# SERVICE LETTER 1989-2C

**SUBJECT:** Normal Criteria for Static Blade Shake and Twist of McCauley Propellers

**MODELS AFFECTED:** All Variable Pitch Propellers

**SERVICE MANUALS AFFECTED:** 720415, 710930, 780630, 701115, 761001, 810915, 790901, 860201, 810301, 880415, 890119, MPC1100-1, CMM1100-1

Figure 1 - Blade Shake

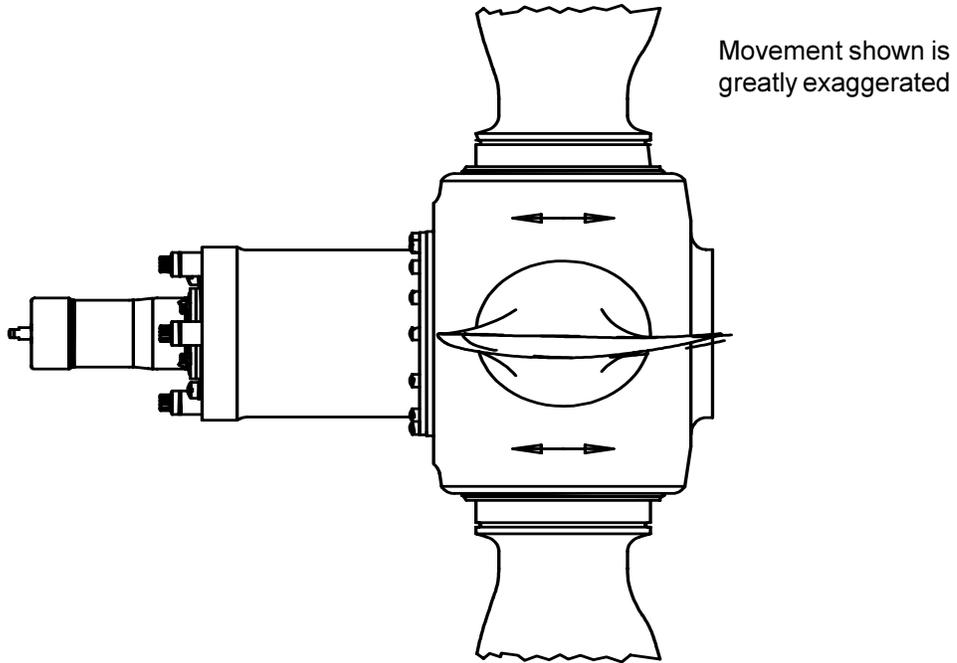
Blade shake is defined as the tendency for the propeller blades to wobble slightly when the tip is physically moved by hand (lead edge to trail edge; see Figure 1). This tendency is a natural result of the fabrication of parts within the McCauley retention system. While accumulation of tolerances is measured in thousandths of an inch, it must be remembered that both the parts causing blade shake, and the pivot point about which the blade rotates, are near the blade root. As a result, very small differences at the blade root will be magnified many times when measured at the tip. Total maximum allowable movement up to 1/8 or .125 inch (3.13mm) is considered normal. C1100 series propellers may have a maximum movement of 3/16 or .1875 inch (4.7mm).

Normal blade shake (less than maximum allowable movement) is no cause for concern, as it disappears during propeller rotation due to the high centrifugal forces acting on the blades (20,000 - 45,000 lbs.).

If, however, blade shake exceeds maximum movement allowable, it should be reduced, *when convenient*, by inserting shims in the blade assembly by an FAA-approved propeller repairman. In many cases, adjustment can be performed with the propellers still installed on the aircraft. Refer to the appropriate McCauley Service Manual for instructions on installing shims.

Figure 2 - Blade Twist

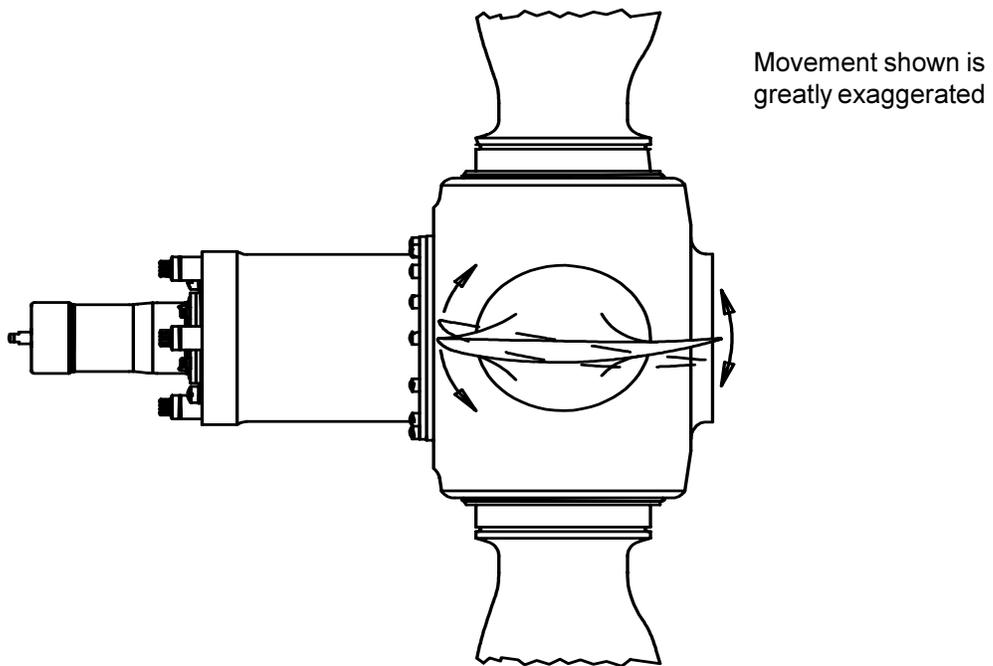
A. The first type is "rotational play" and can be defined as the sum total of rotational movement a propeller blade allows when moved by hand around its axis of rotation (see Figure 2). This movement is, to a limited degree, considered normal and should not be cause for concern. Please note that, while a specific rotational movement limit is no longer given, all blades in a propeller should have about the same amount of "rotational play". If the *difference* in rotational play between two blades is beyond 1.0 degree, uneven internal wear and/or damage is the possible cause.

(For example, rotational movement of No. 1 blade measures 1.2 degrees, and No. 2 blade measures 2.3 degrees. This would be considered excessive since their difference is beyond 1.0 degree.) The cause of the excessive difference should be determined by an FAA approved propeller repairman or international equivalent at the next opportunity.
